Product Change Notification

Issue Date: November 03, 2014

Product Name: NANO-QM871 SBC

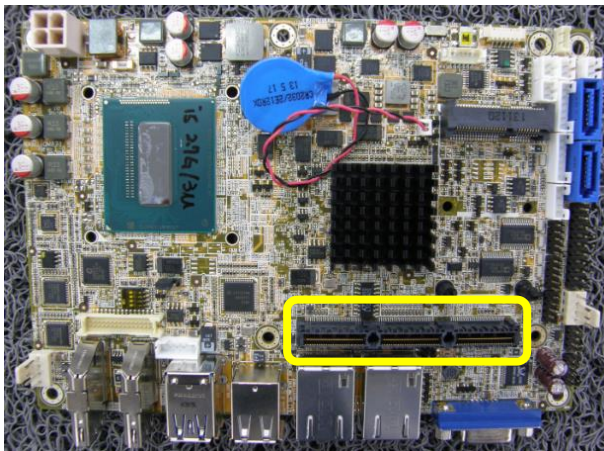
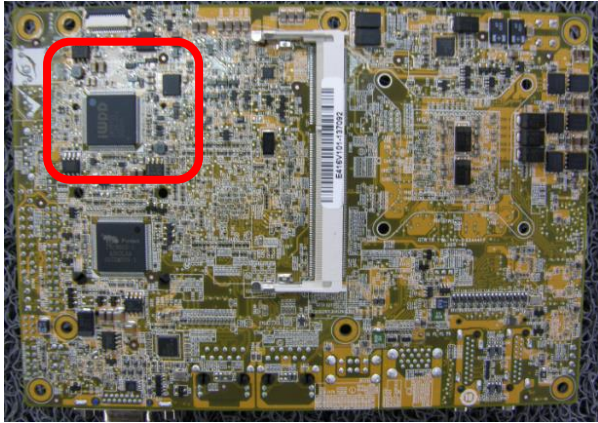
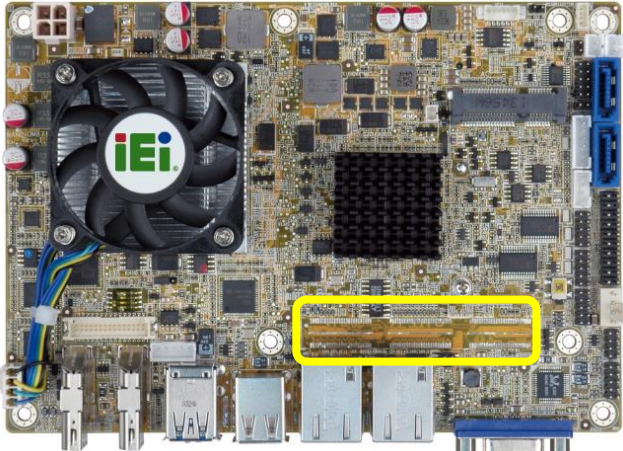
1. Set default as removing PCI/104-Express™ Type II slot on top side, this function will be optional.
2. Increase iRIS-1010 slot on bottom side.
- 3.
